**Cookson Plibrico Relocation Project – Unanderra NSW
Response to Wollongong City Council Assessment Comments
MP-2009/45, 2 September 2009**

Acoustic Studio response to comments made by Wollongong City Council (letter from Wollongong City Council dated 2 September 2009).

Figure 1 : Operational Noise Contour Diagram - $\text{dBL}_{\text{Aeq}, 15\text{min}}$ at 5 dB intervals.

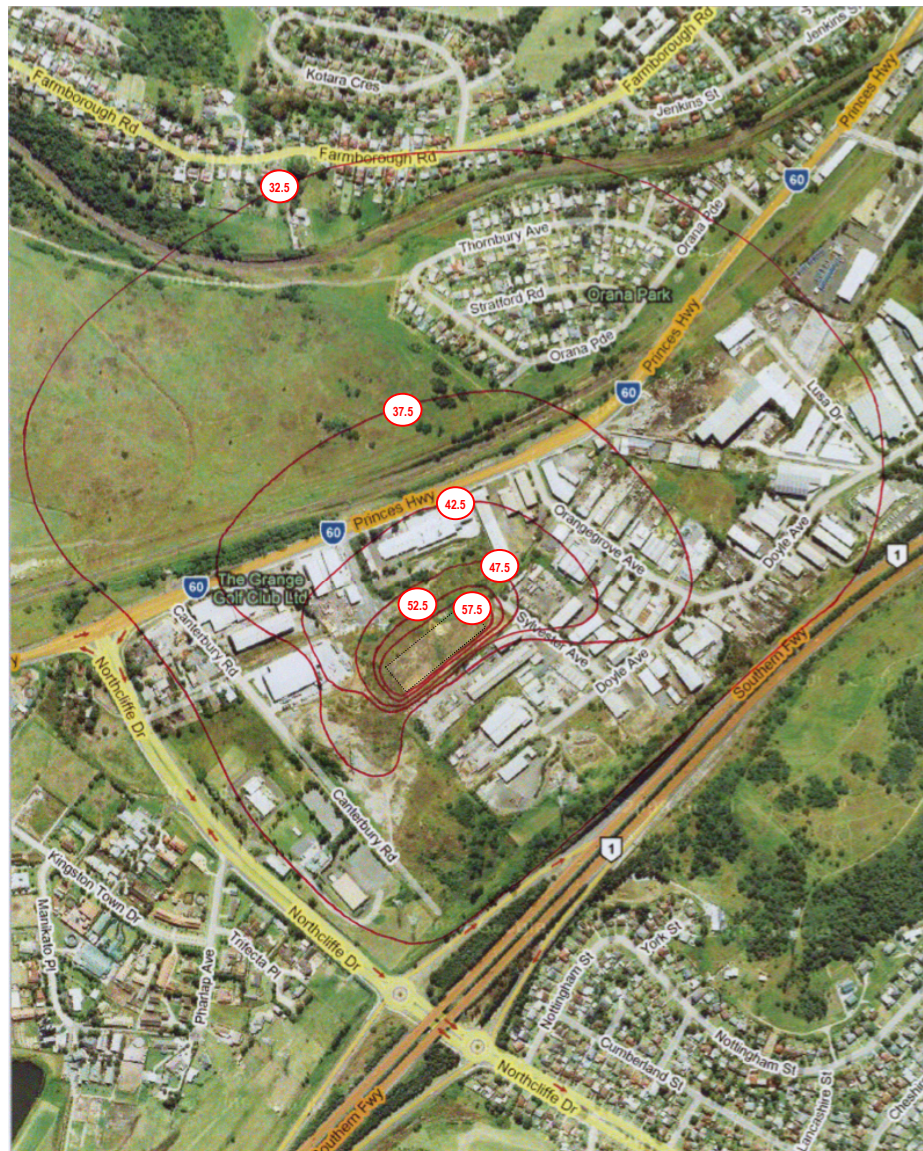
Item 3 : Noise Contour Diagram

The topography of the area, plus existing buildings, is such that the non-industrial developments to the south, east and west, including the Canterbury Road properties, are naturally screened/shielded from the site.

This results in a lower exposure of these properties to operational noise from the proposed site. This can be seen in the noise contour diagram provided in Figure 1 (provided in response to WCC Item 3).

Noise contours are presented in Figure 1. The noise contours indicate the predicted operational noise levels around the site under the typical operating conditions of the facility. This is consistent with Operating Scenario 1 from the Noise Impact Assessment.

The predicted operational noise levels are equivalent continuous sound pressure levels over a 15-minute assessment period, $\text{dBL}_{\text{Aeq}, 15\text{min}}$.
